Acceptable Means of Compliance and Guidance Material to Annex VI (Part-AIS) to Commission Implementing Regulation (EU) 2017/373

Issue 1, Amendment 3

Annex II to ED Decision 2024/006/R

'AMC and GM to Part-AIS — Issue 1, Amendment 3'

AMC1 AIS.OR.325 Aeronautical charts

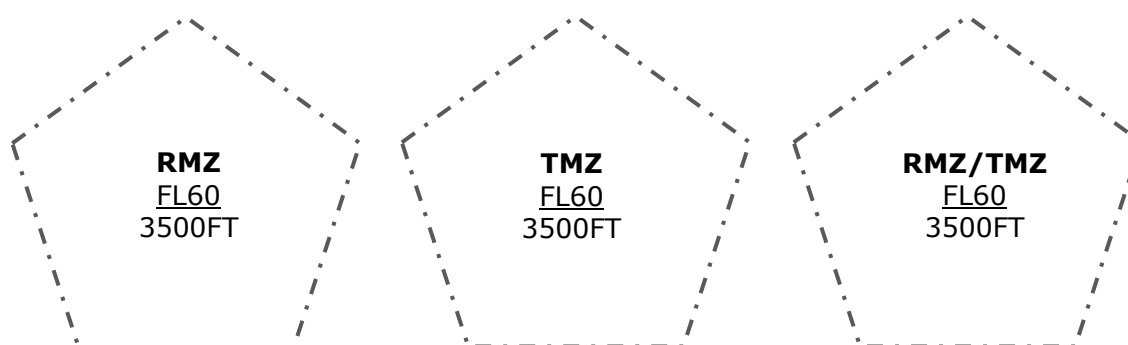
Aeronautical charts should be produced in accordance with the specifications contained in ICAO Annex 4, Amendment No 61, except that any radio mandatory zones (RMZs) and transponder mandatory zones (TMZs) should be depicted on the 'En-route chart – ICAO', the 'Visual approach chart – ICAO' and the 'Area chart – ICAO', as follows:

- (a) the radio mandatory zones and the transponder mandatory zones should be displayed with an RMZ tag and a TMZ tag respectively, and, if both zones are defined for a specific area, with an RMZ/TMZ tag. The vertical limits of the zone should be indicated under the tag. A thick, dark, grey-dashed and dotted line should be used to show the boundaries of the zones in all cases.
